Subject: Dresden Station Units 2 and 3  
Quad Cities Station Units 1 and 2  
Additional Information Pertaining to The  
Resolution of Single Failure Vulnerabilities  
Associated with Combustible Gas Control  
NRC Docket Nos. 50-237/50-249 & 50-254/50-265

## NRC Technical Concern and Operational Questions Combustible Gas Control Dresden and Quad Cities Station

## Proposed Modifications Combustible Gas Control Dresden and Quad Cities Station

## Post-LOCA System Inerting Pathways Compensatory Measure Implementation Combustible Gas Control Dresden and Quad Cities Station

CONCEPTUAL DESIGN FOR PROPOSED MODIFICATIONS  
 DRESDEN STATION UNITS 2 & 3  
**FIGURE 3**

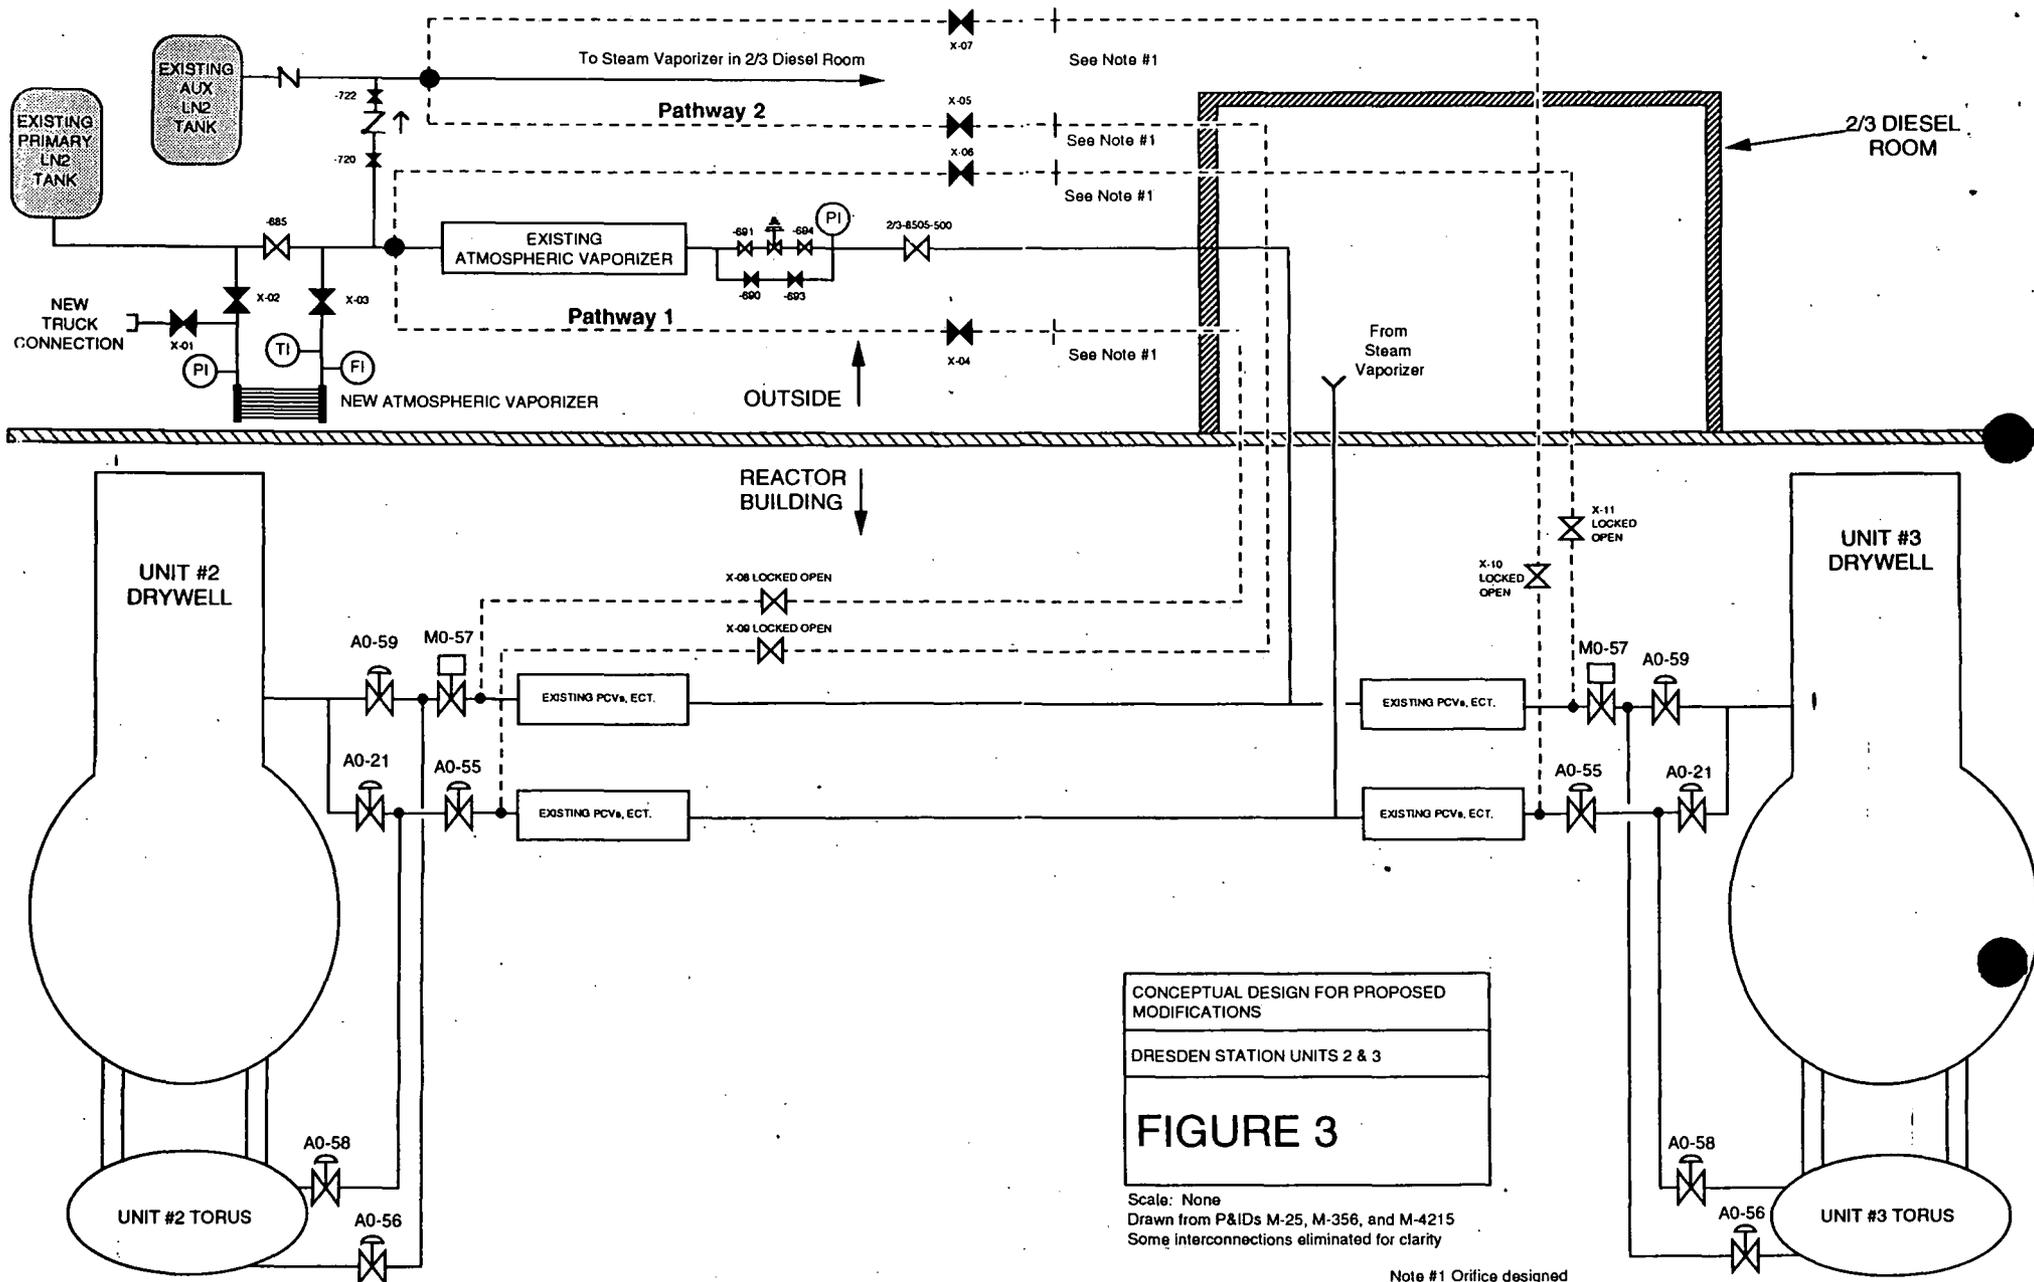
The primary design differences between the Nitrogen Inerting and Makeup system at Dresden and Quad Cities station are depicted in Figures 3 and 4, and listed below. However, following implementation of the proposed modifications (see Attachment B), the post-LOCA design configuration at Dresden and Quad Cities stations will be essentially identical.

**DRESDEN**

Primary and auxiliary nitrogen tanks

Atmospheric vaporizer (Makeup pathway)

Single flow path from each tank with crosstie between tanks

No Cold valves

CECo has developed a proposed resolution to this vulnerability which would require a modification to the system (Figures 3 and 4). This proposed modification involves the addition of a redundant line around the inaccessible manual isolation valve(s) for each unit at Dresden and Quad Cities Stations. Each redundant line will be equipped with two manual isolation valves. One of the new manual isolation valves will be located at the nitrogen tank, outside of the Reactor Building, and therefore will be accessible following a LOCA. An additional manual isolation valve for each redundant line will be located directly inside the Reactor Building. Due to the post-LOCA conditions in the Reactor Building, these valves will be locked open during normal power operation. In order to minimize the potential for inadvertent containment pressurization during normal power operation, the new manual isolation valves located at the nitrogen tank will be locked closed during normal power operation.

- Addition of a redundant line (with manual isolation valves) to the Makeup pathway for each unit;
- Installation of a flow orifice in each redundant line, sized to deliver 30 scfm at 30 psig in containment; and,
- Installation of an atmospheric vaporizer with monitoring instrumentation, sized to be capable of vaporizing the maximum postulated nitrogen flow.

This proposed configuration will then: 1) provide a bypass around the manual isolation valves, pressure reducer, and Pressure Control Valve (PCV) on the Inerting system; 2) provide a bypass around the PCV, pressure reducer, and Cold valves (Quad Cities specific) on the Makeup system; and, 3) provide a passive method to vaporize liquid nitrogen provided by off-site vendors. These enhancements will:

CONCEPTUAL DESIGN FOR PROPOSED MODIFICATIONS  
 QUAD CITIES STATION UNITS 1 AND 2  
**FIGURE 4**

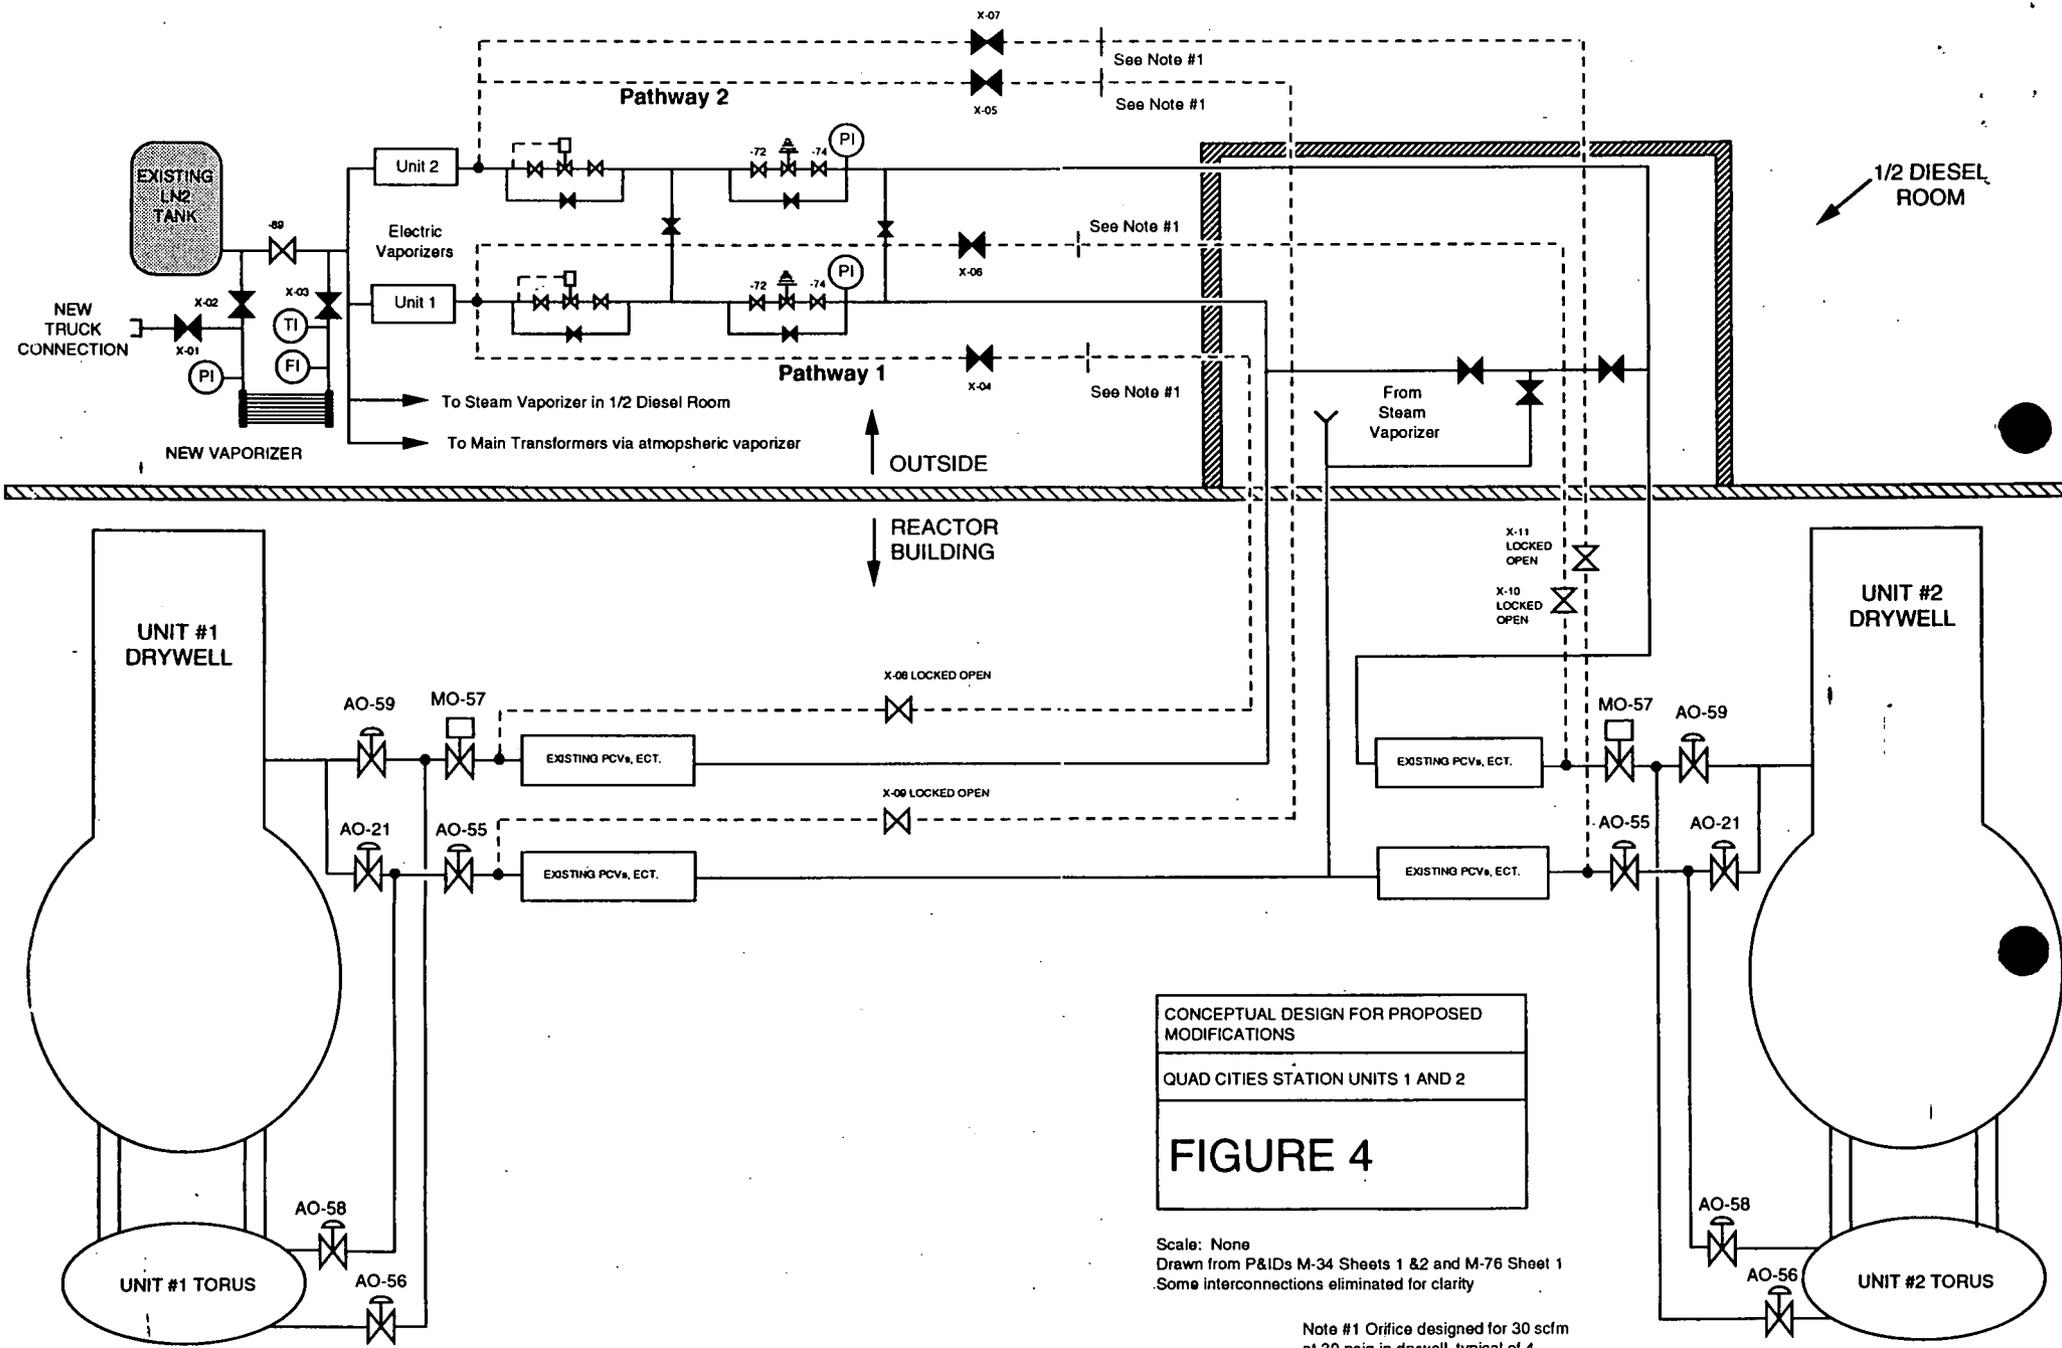
**QUAD CITIES**

Single main nitrogen tank

Two electric vaporizers

Redundant flowpath from single tank (with crosstie)

Cold valves on each flowpath

The Nitrogen Inerting and Makeup system at Quad Cities Station is equipped with "Cold" valves, which are designed to automatically prevent the entry of liquid nitrogen into containment. However, upon installation of the modifications described in Attachment B, the Cold valves at Quad Cities Station will be bypassed during post-LOCA inerting operations. This configuration will not preclude the injection of nitrogen into the containment upon failure of the Cold valves (see Figures 3 and 4).
